HUNTS GROVE
GLOUCESTERSHIRE

Section 73 Planning Application

ADDENDUM TO THE DESIGN & ACCESS STATEMENT

June 2015

LANDSCAPE STRATEGY PLAN (SUPPLEMENTAL ES FIGURE 2.6)

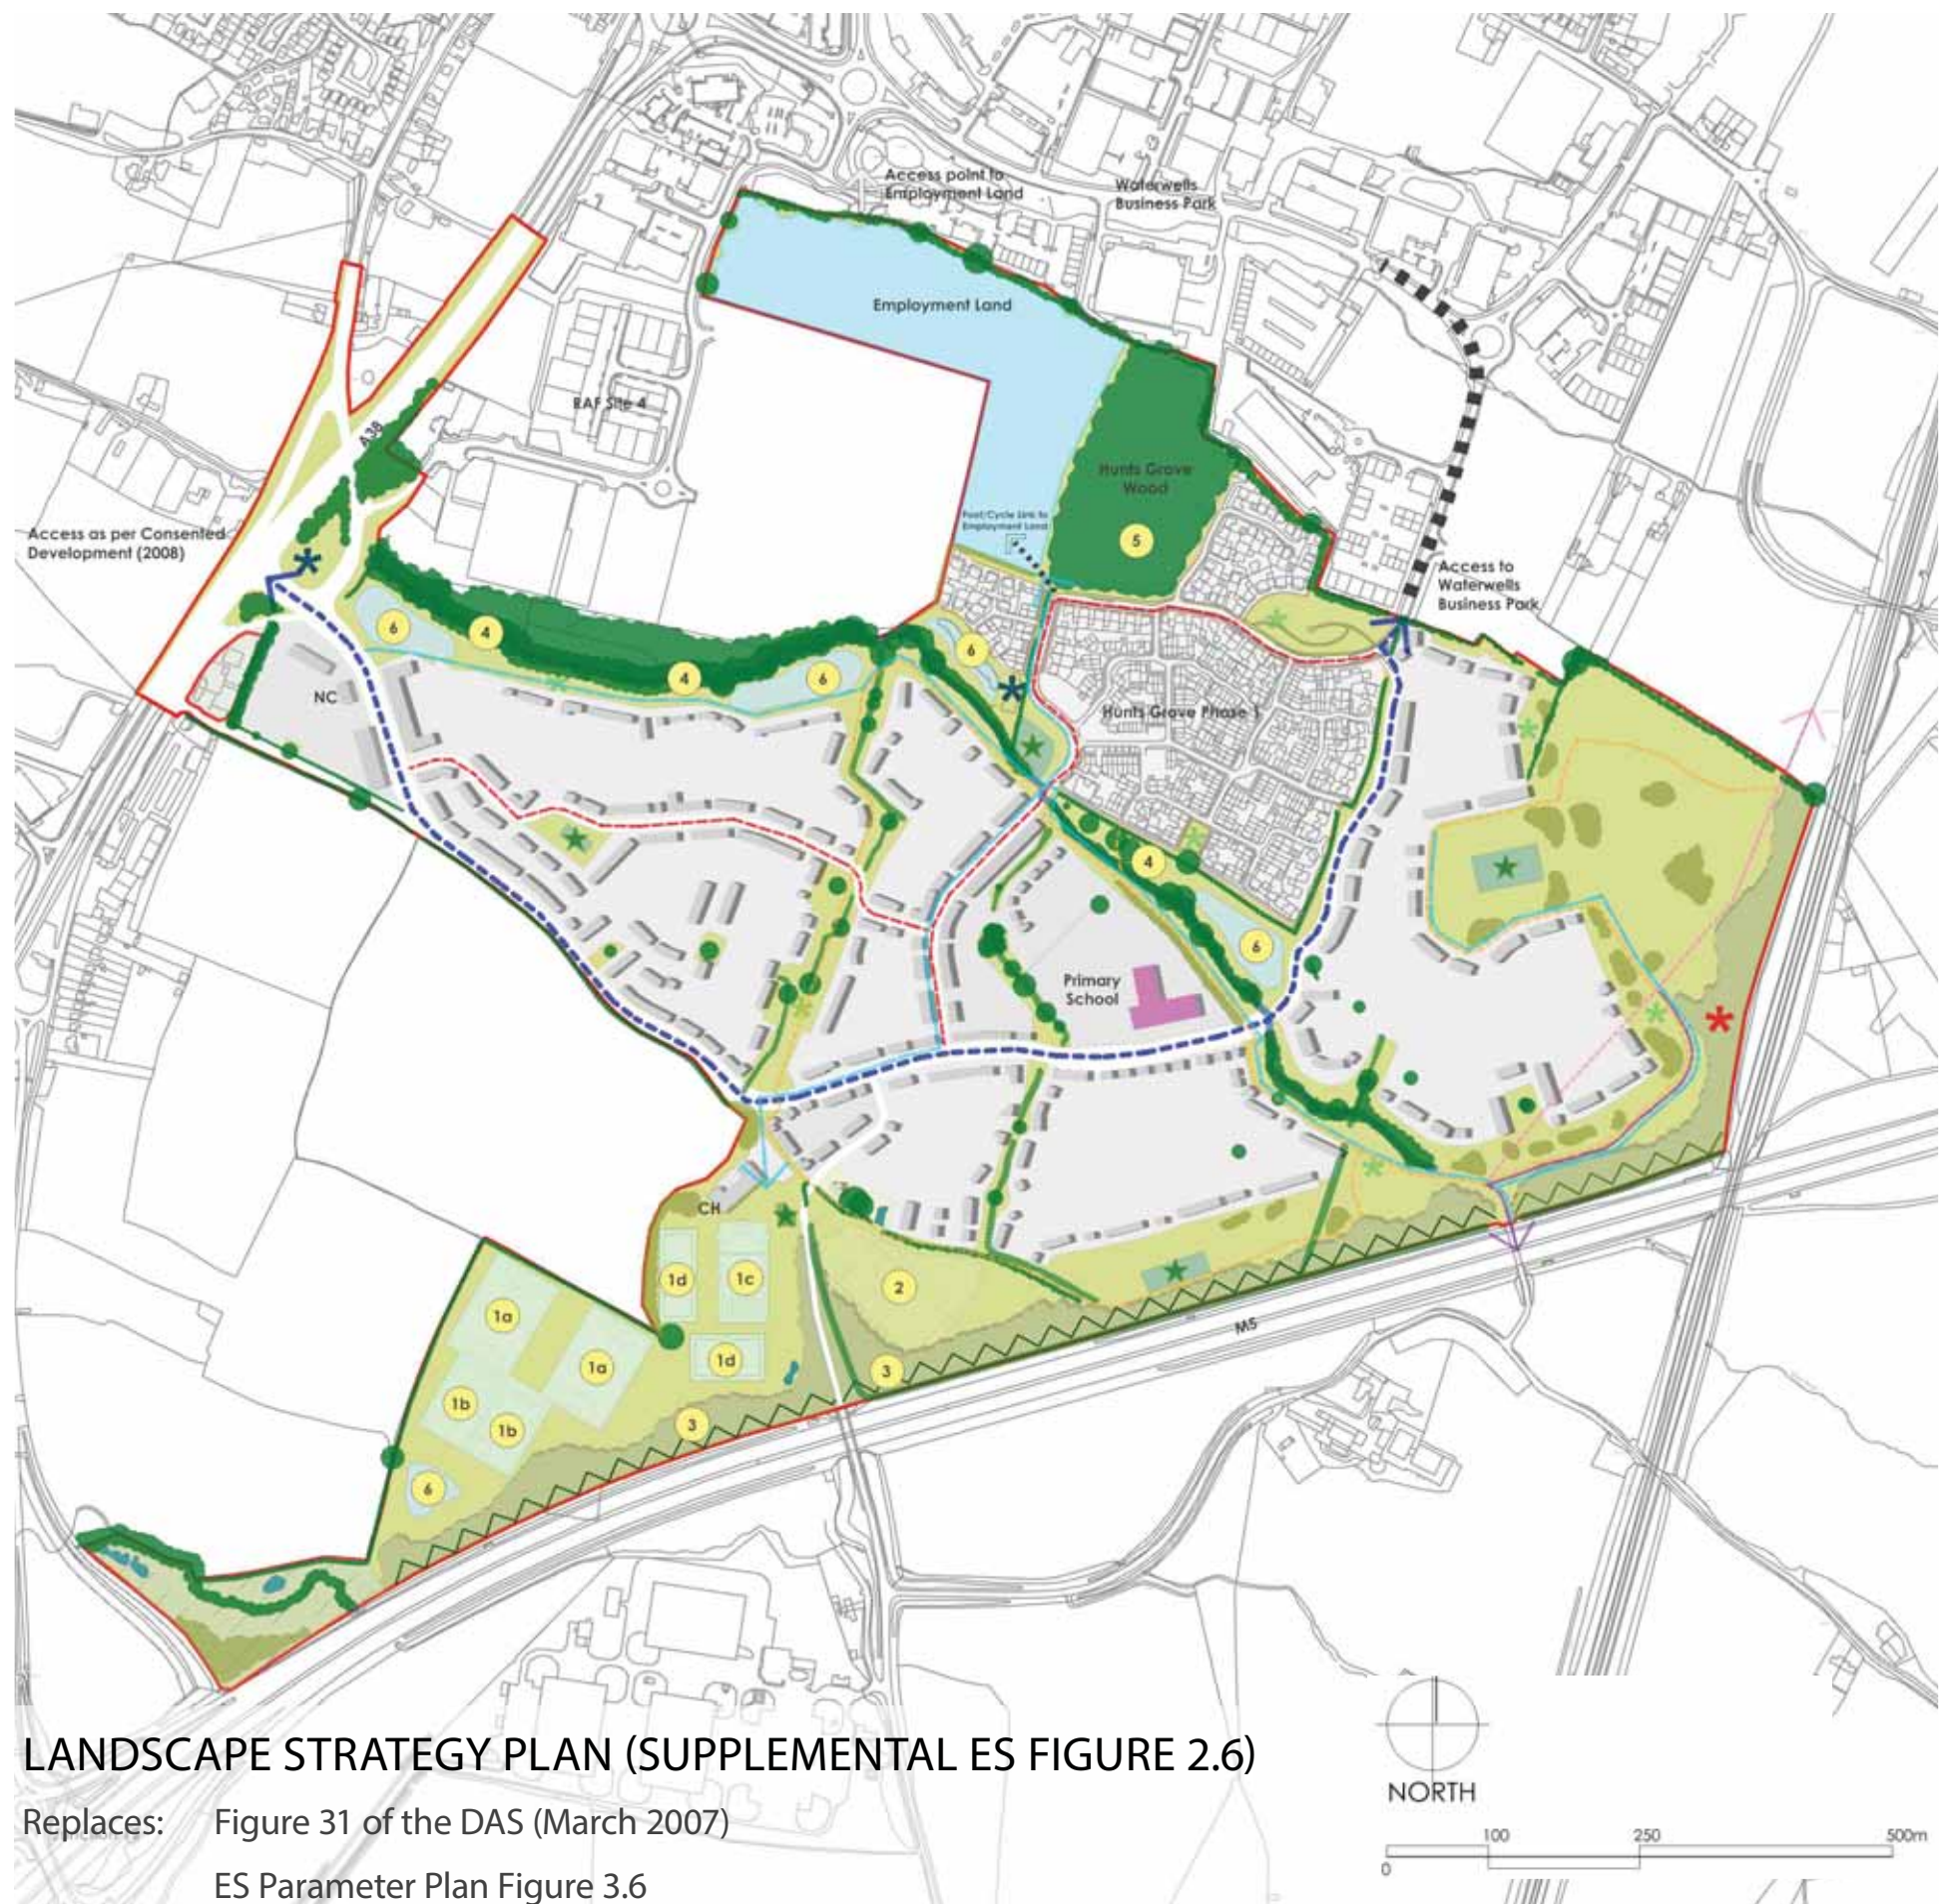
KEY CHANGES

- *The central green corridor has been rationalised, with localised widenings to ensure it delivers an attractive, usable linear park with foot/cycle connections*
- *Several short sections of hedgerow, including much of the northern hedgerow along Haresfield Lane are to be removed, and replaced with new planting to create a more connected and attractive streetscape appropriate for a residential development*

RECREATION PROVISION PLAN

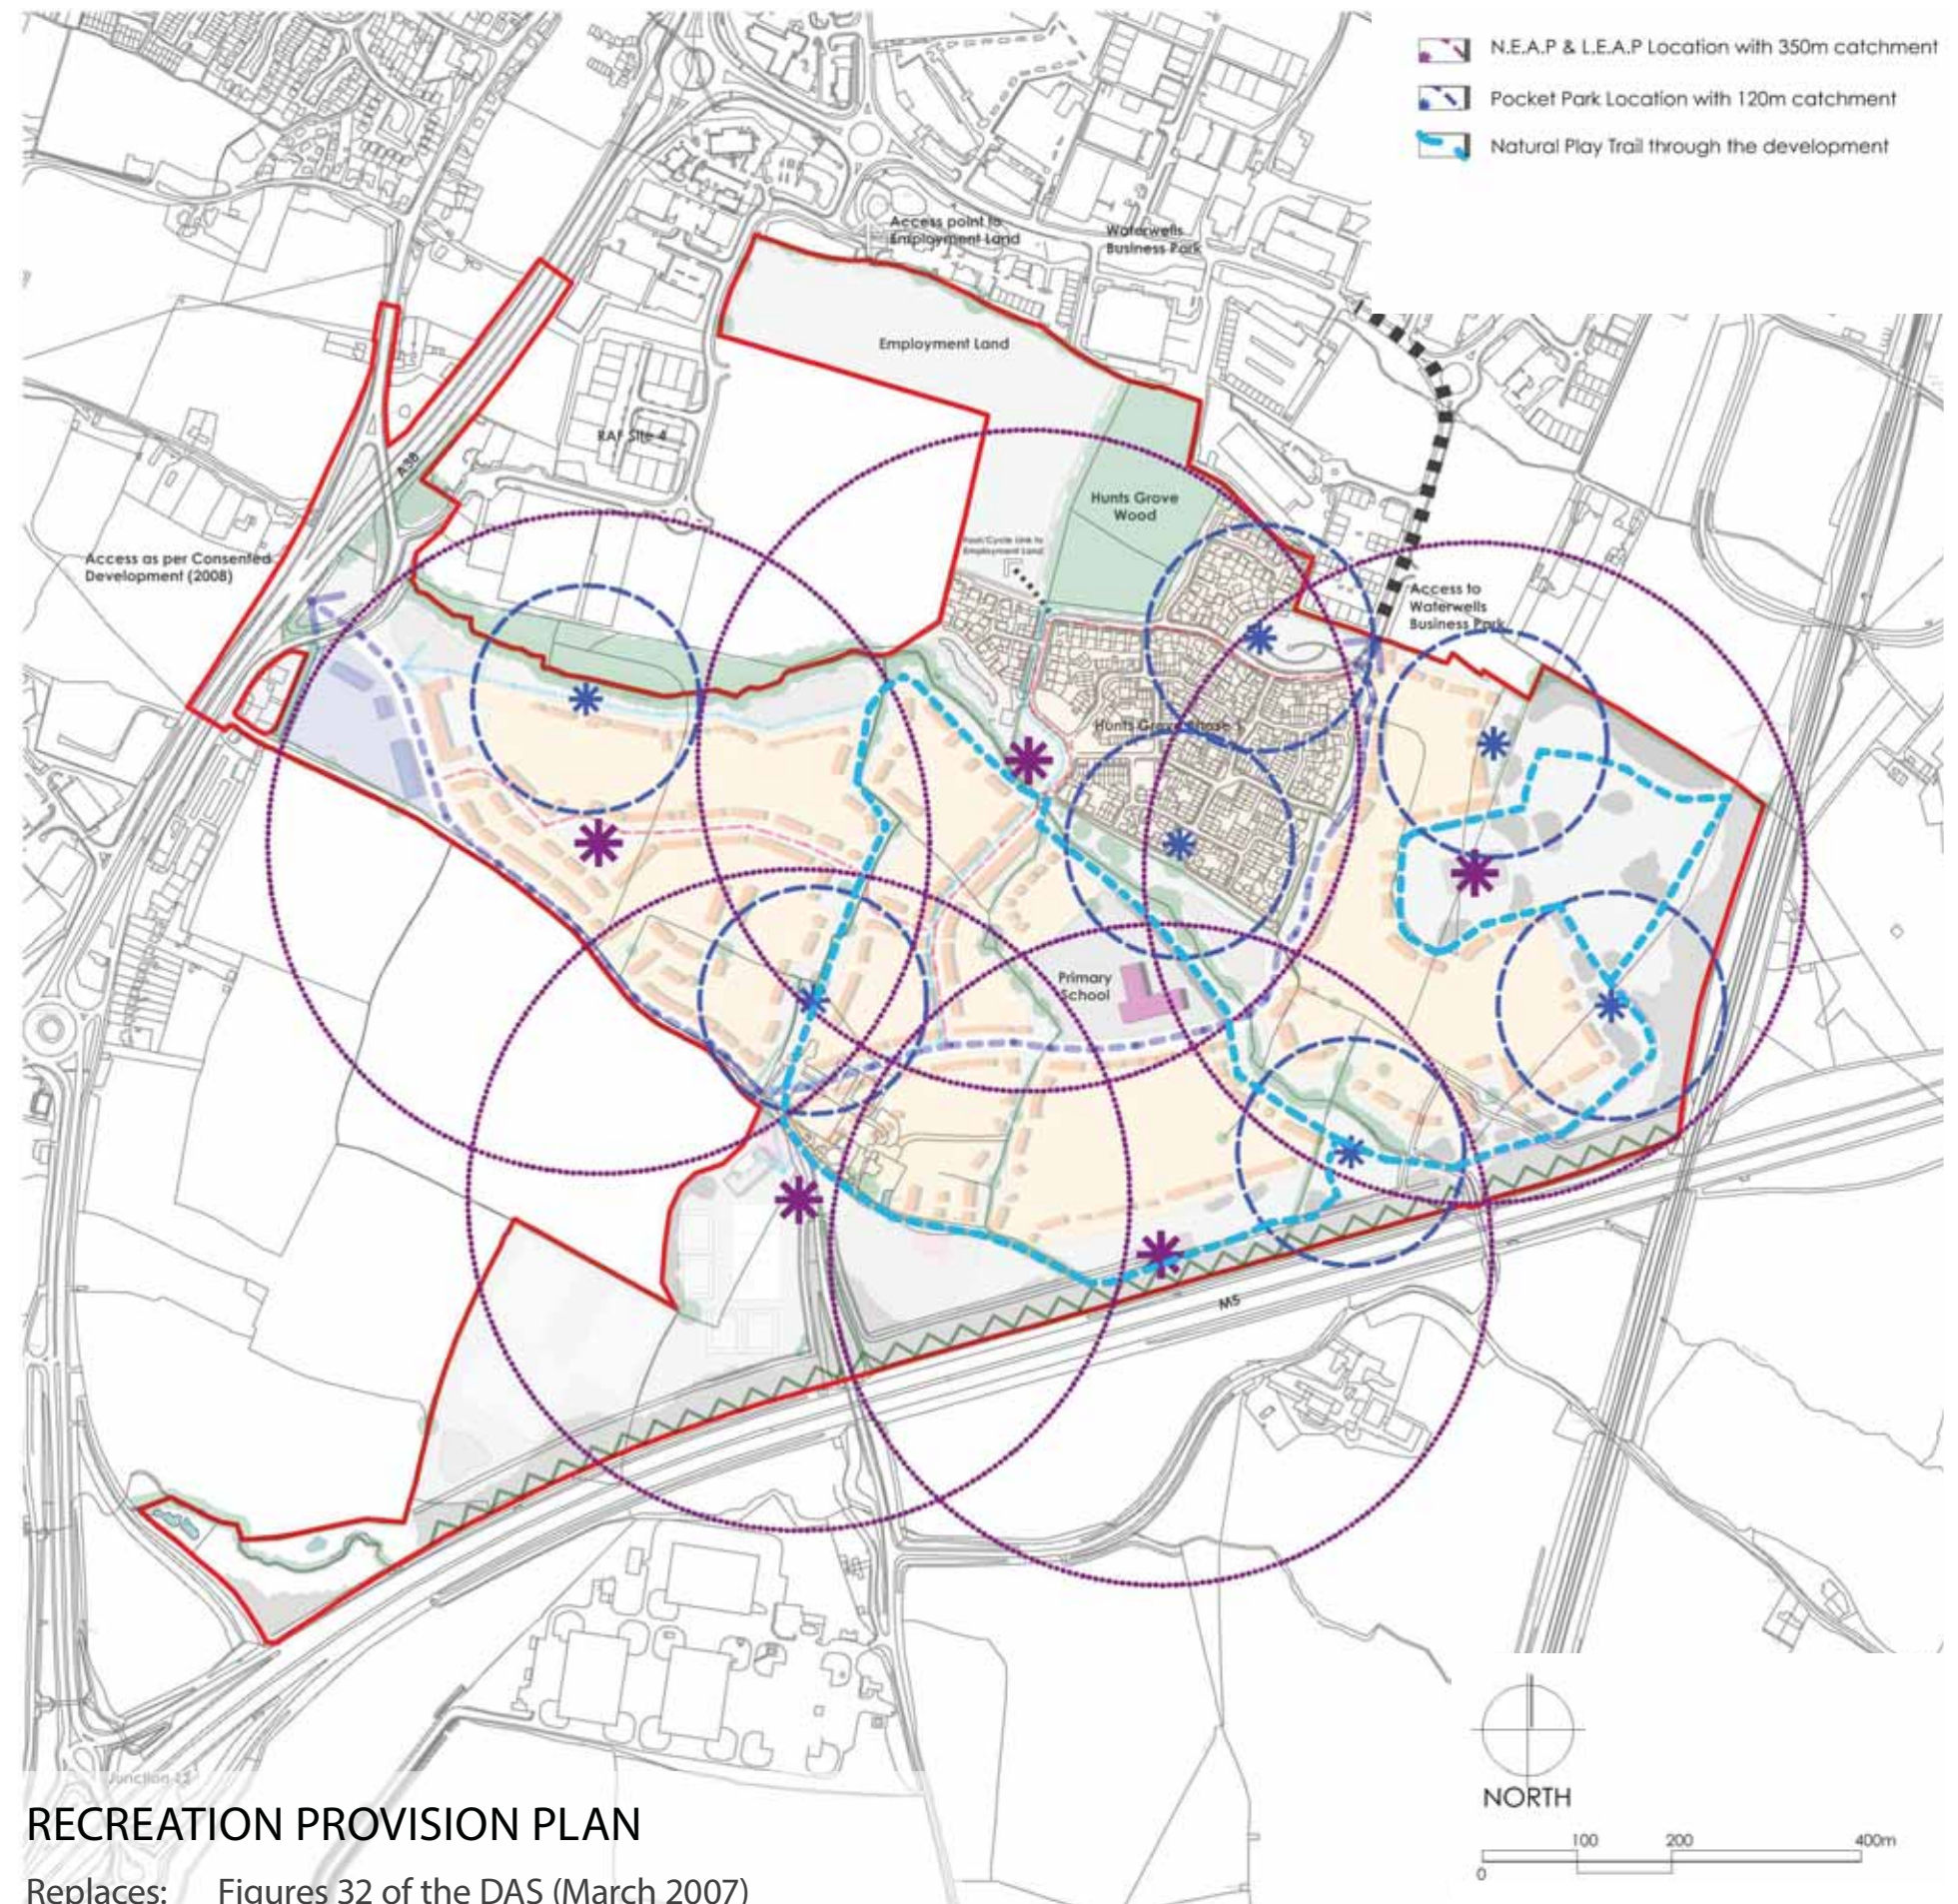
KEY CHANGES

- Relocation of the northwestern LEAP slightly further from the other major play areas into a more enclosed, focal location to better serve this part of the site
- The introduction of four pocket parks to rationalise the provision of smaller play areas
- The introduction of a play trail to provide circular routes within the green corridors and linking areas of incidental natural play as well as more formal play areas and pocket parks

PHASING PLAN (SUPPLEMENTAL ES FIGURE 2.5)

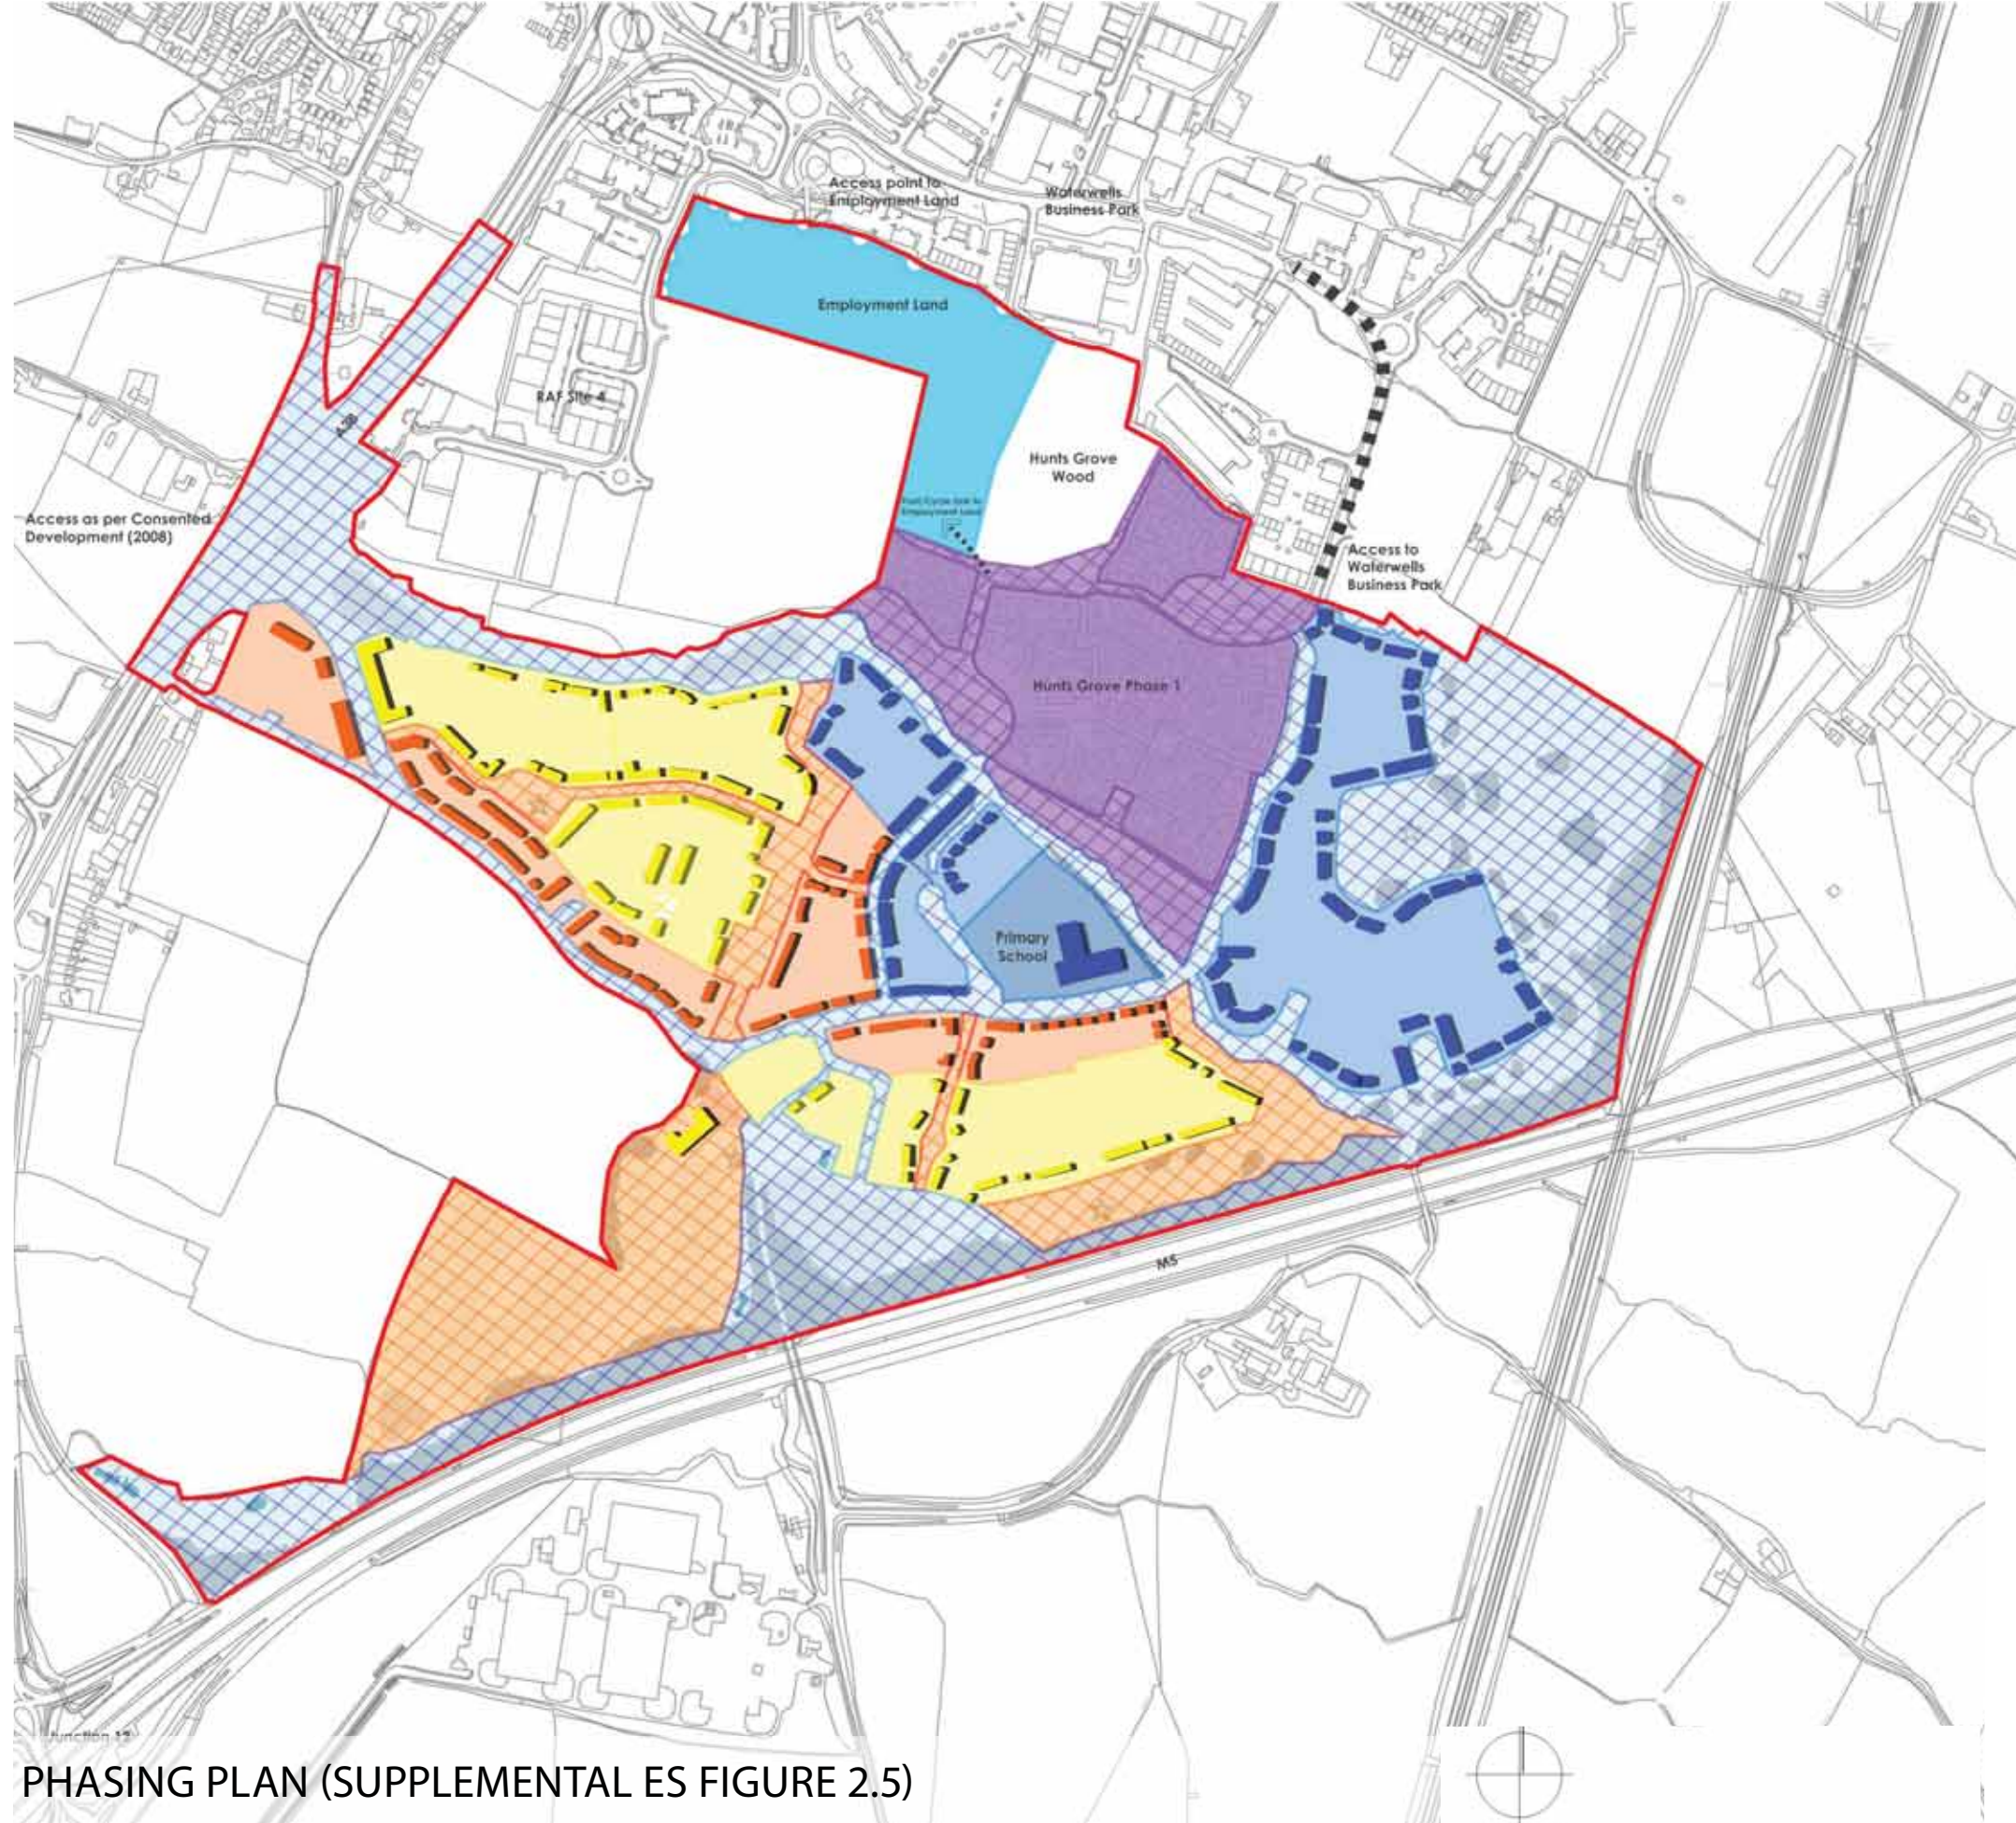
KEY CHANGES

- Phase 1 development at Hunts Grove began at the Waterwells access and Phase 1A will continue from here to provide the primary school
- Phase 2 will now include the A38 junction
